RS-11-136
September 2, 2011

Braidwood Station, Units 1 and 2
Facility Operating License Nos. NPF-72 and NPF-77
NRC Docket Nos. STN 50-456 and STN 50-457

Byron Station, Units 1 and 2
Facility Operating License Nos. NPF-37 and NPF-66
NRC Docket Nos. STN 50-454 and STN 50-455

Subject: Response to Request for Additional Information Related to License Amendment Request to Revise Technical Specifications (TS) 3.3.1, "Reactor Trip System (RTS) Instrumentation," and TS 3.3.2, "Engineered Safety Feature Actuation System (ESFAS) Instrumentation," to Reflect Installation of Bypass Test Capability

ATTACHMENT 11
Supporting Information

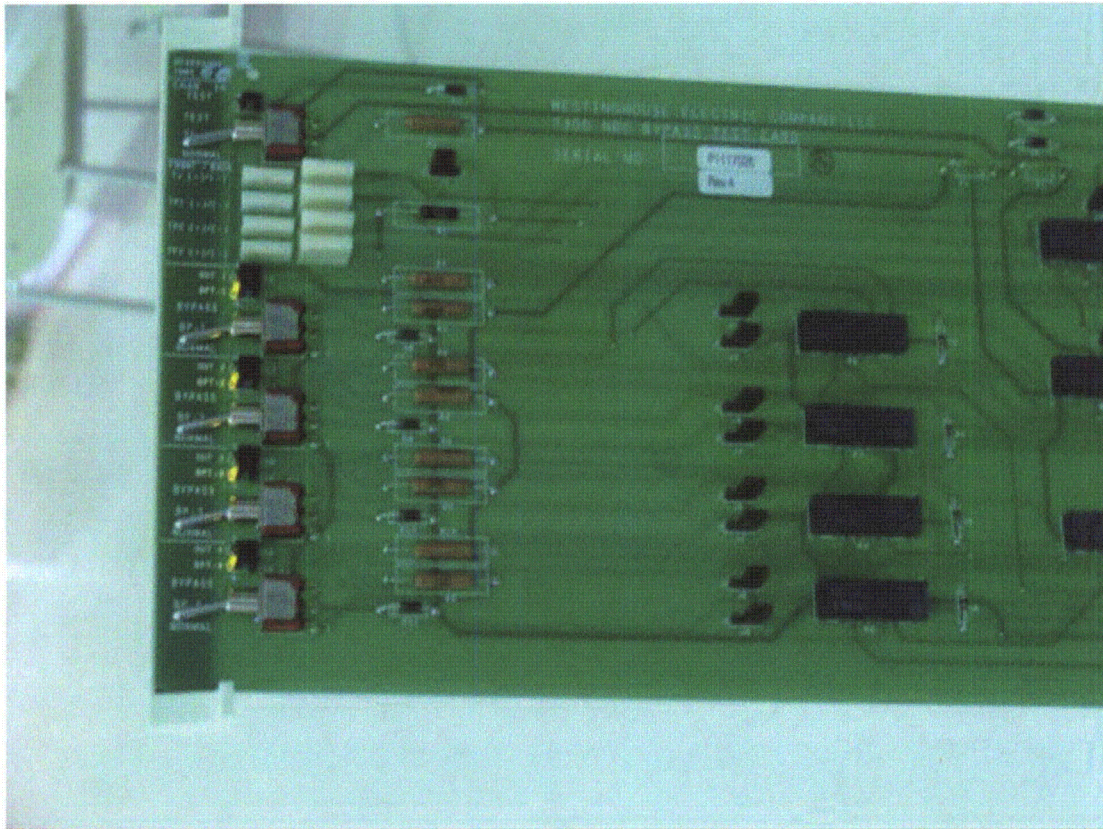
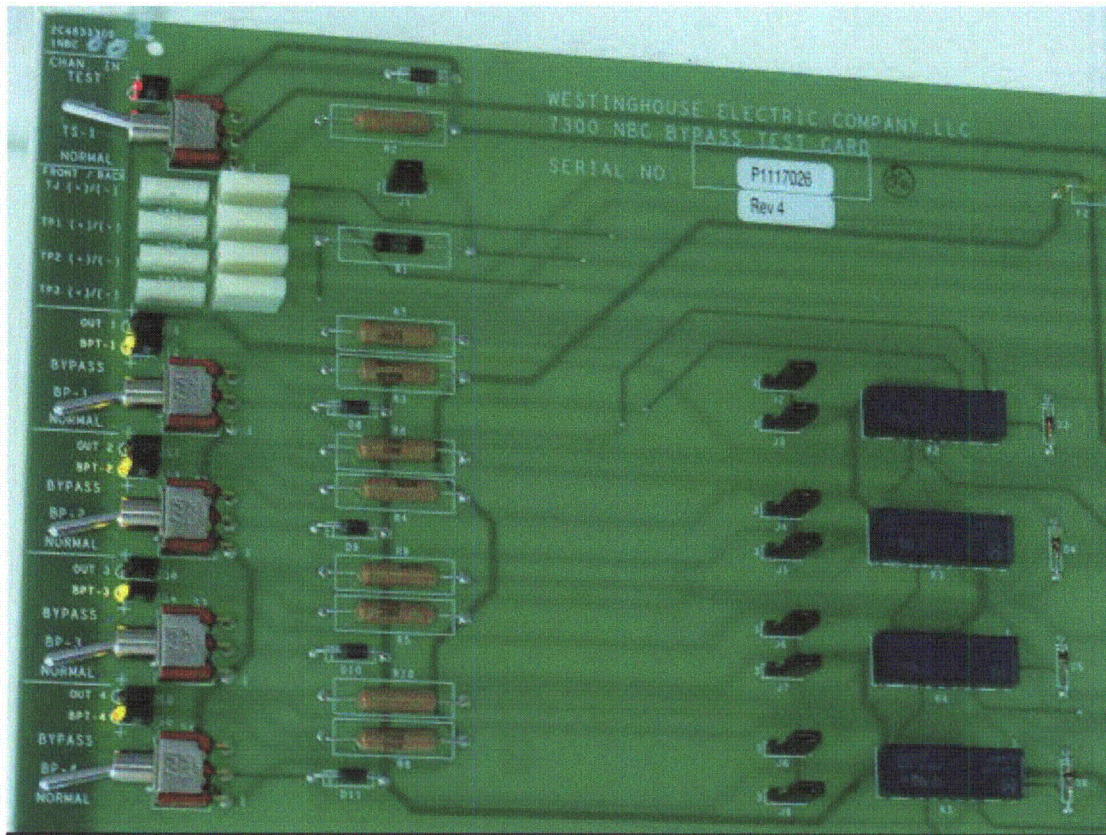
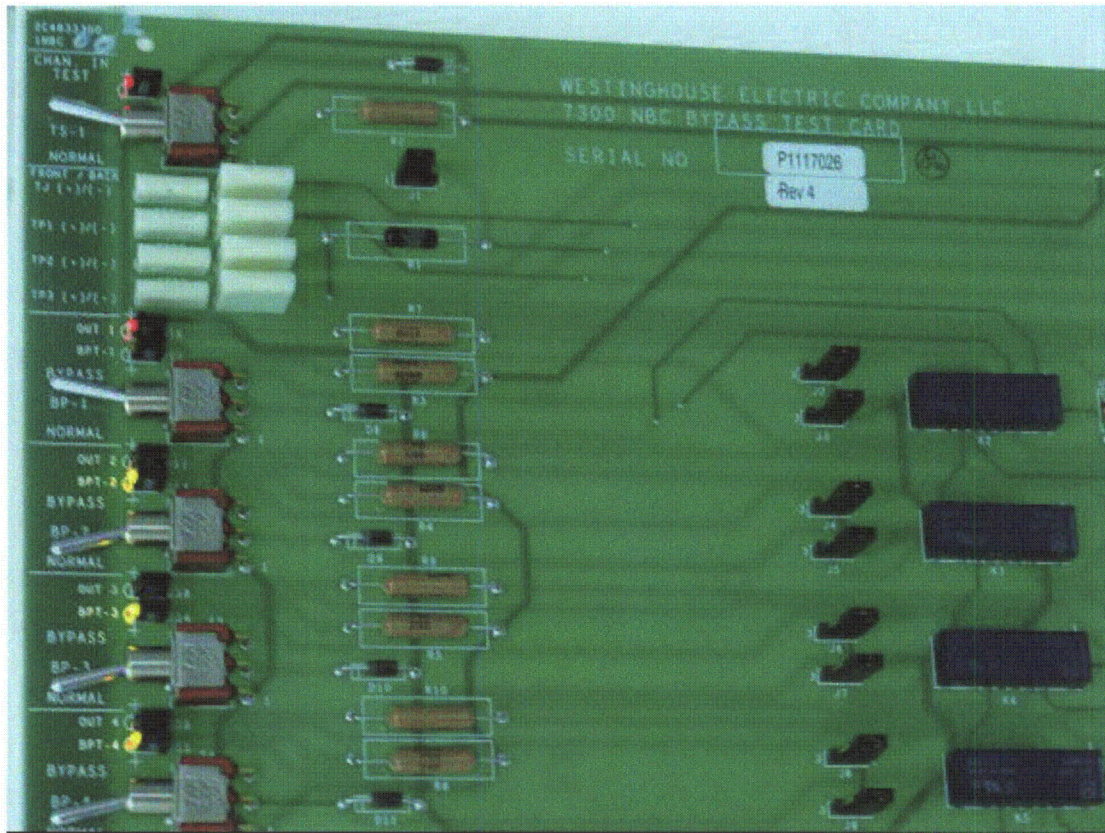
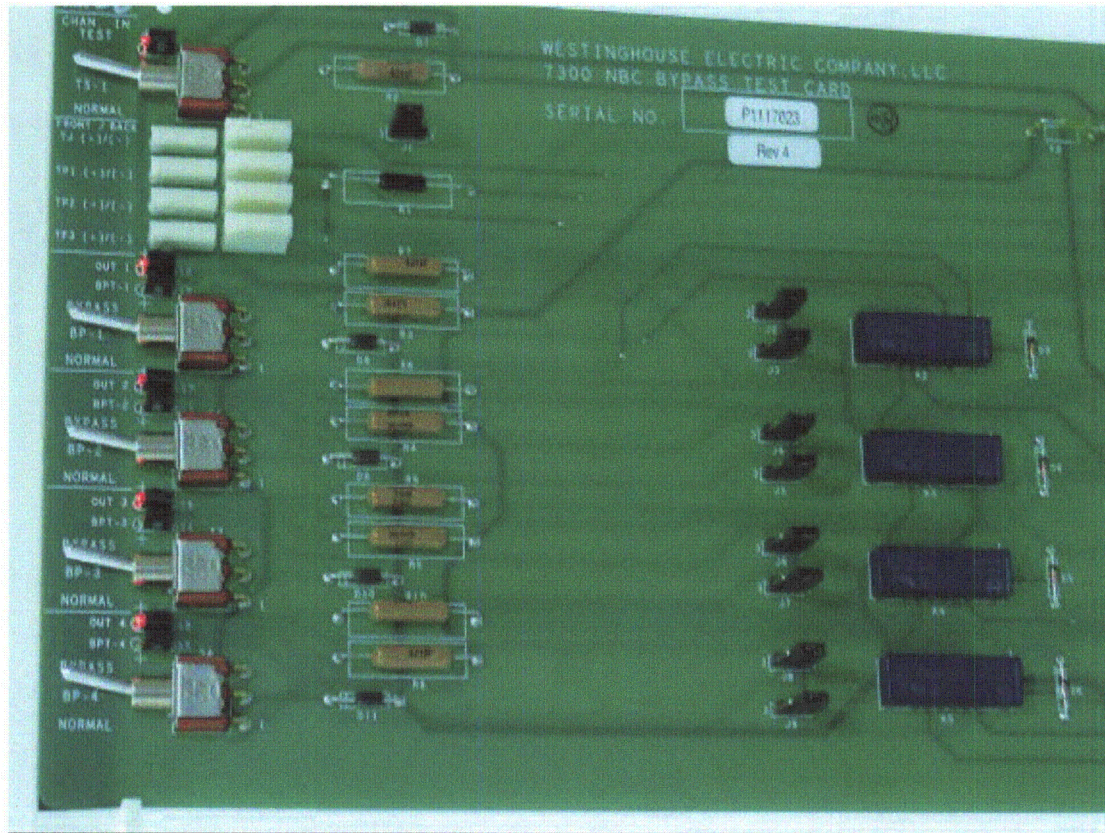
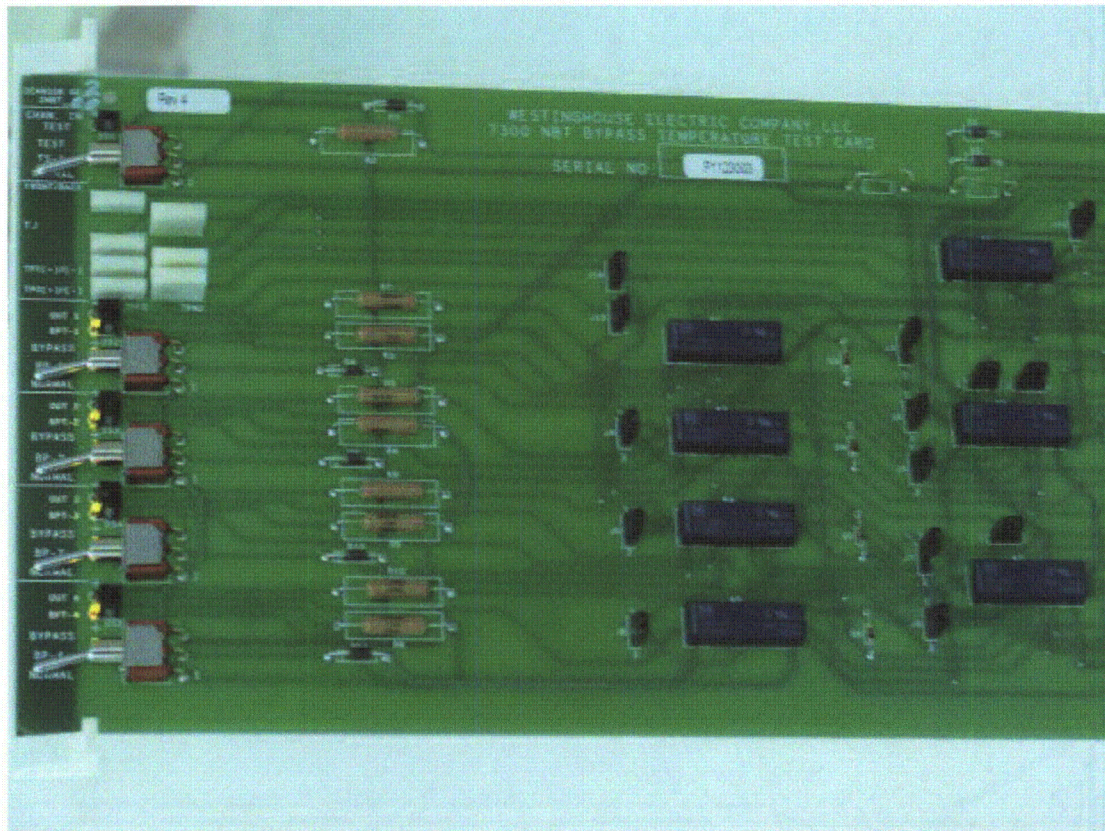
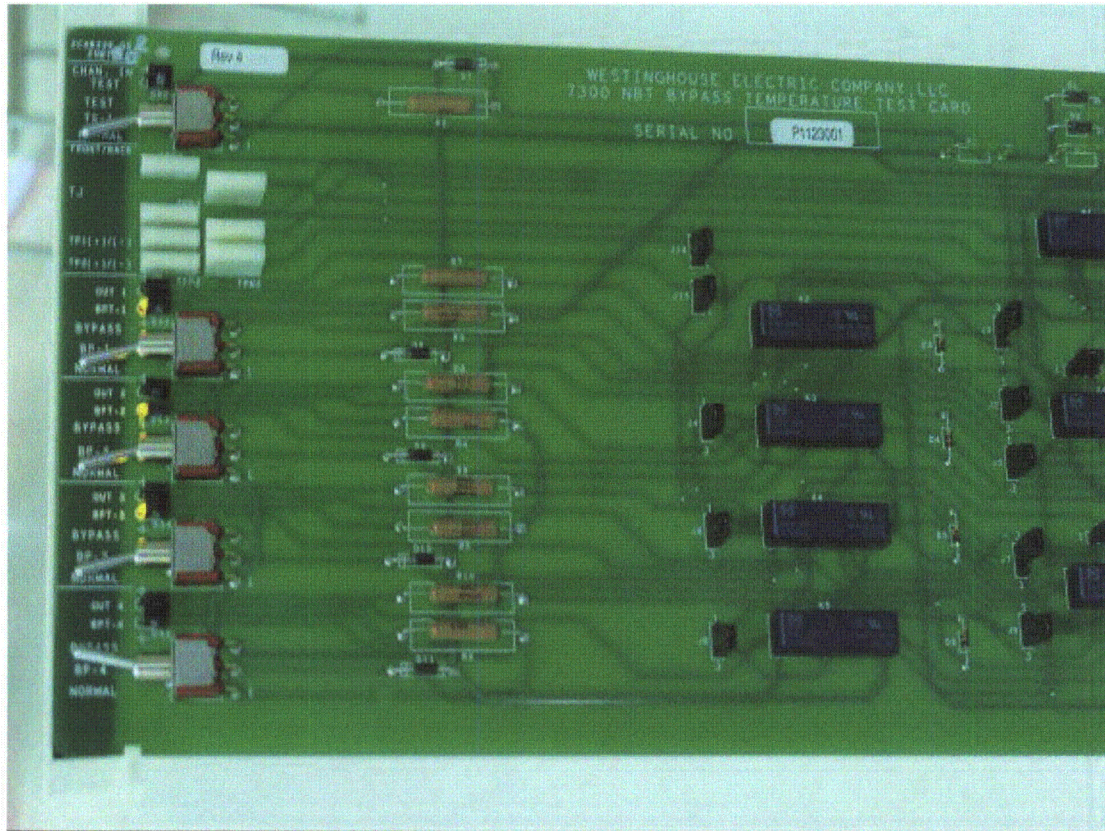
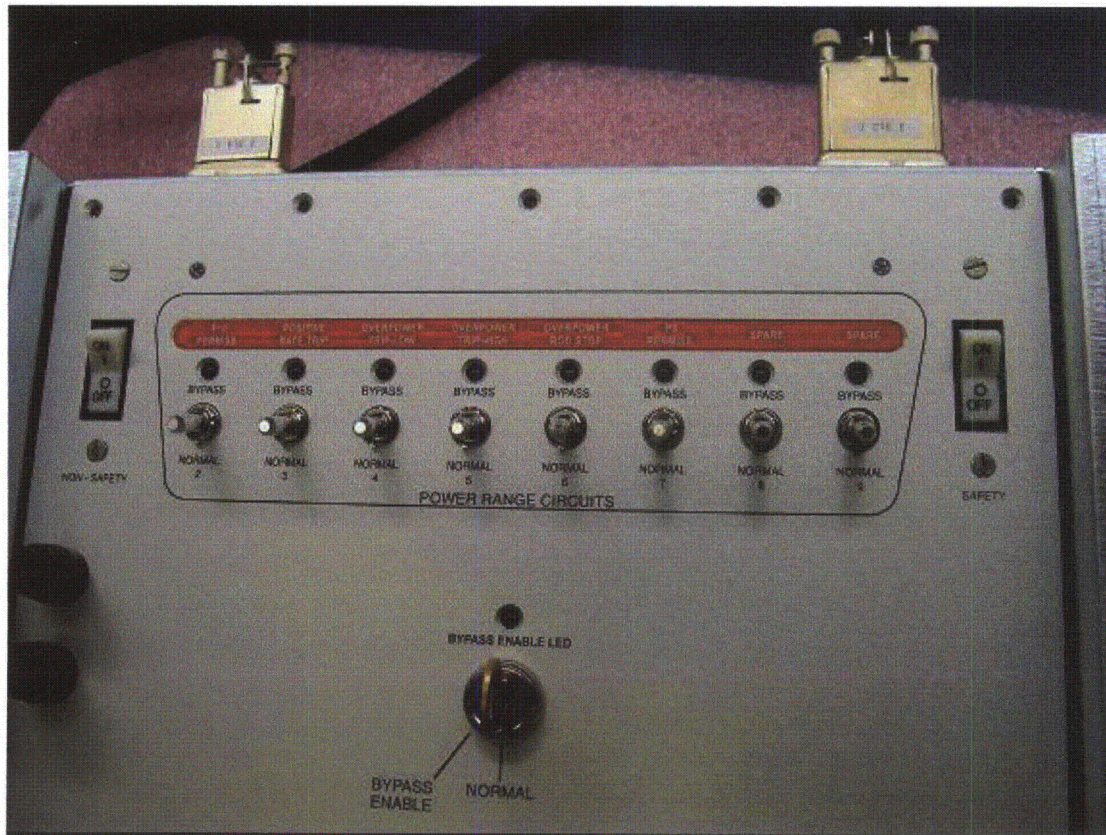
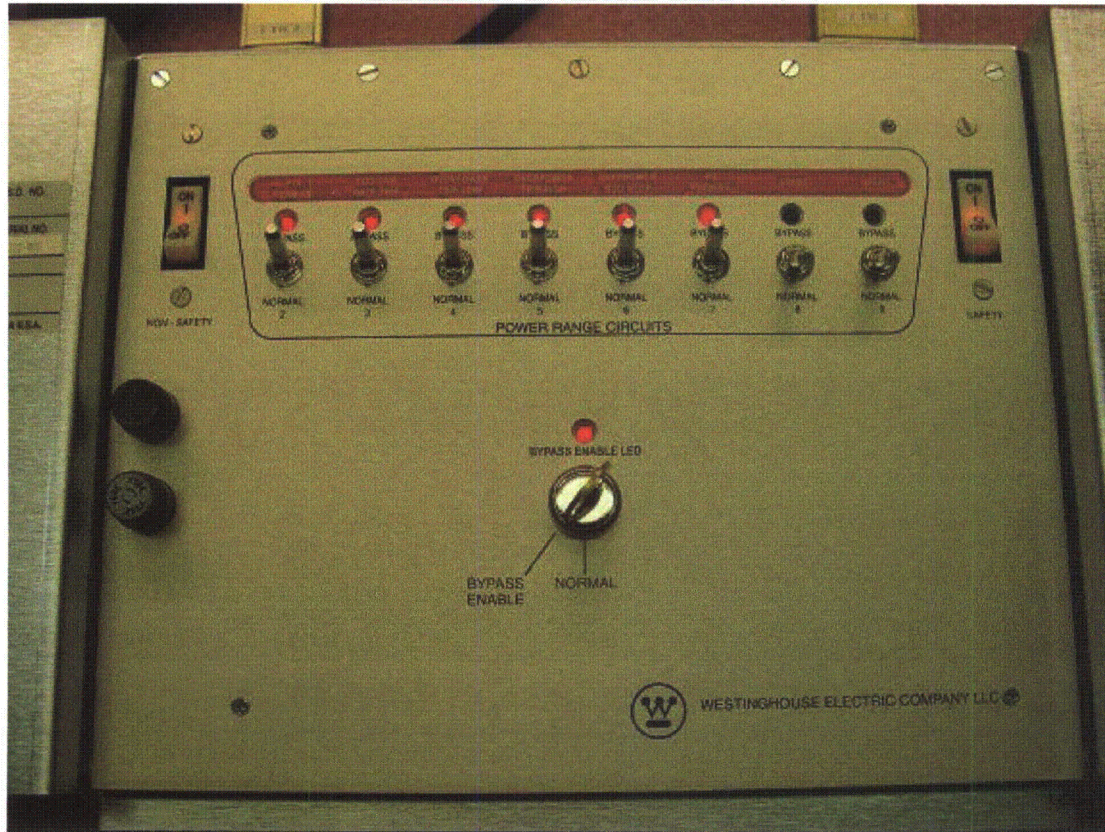
NRC Question 1:

Provide the schematic diagrams with and without bypass circuitry to illustrate the reactor trip functions with and without bypass capability and the pictures of the Nuclear Instrumentation System Bypass Panel and 7300 Bypass Protection System including the bypass keylock switches, toggle switches, and indications.

Pictures of the NIS Bypass Panel and 7300 Bypass Protection System are provided in Attachment 11 to this submittal.
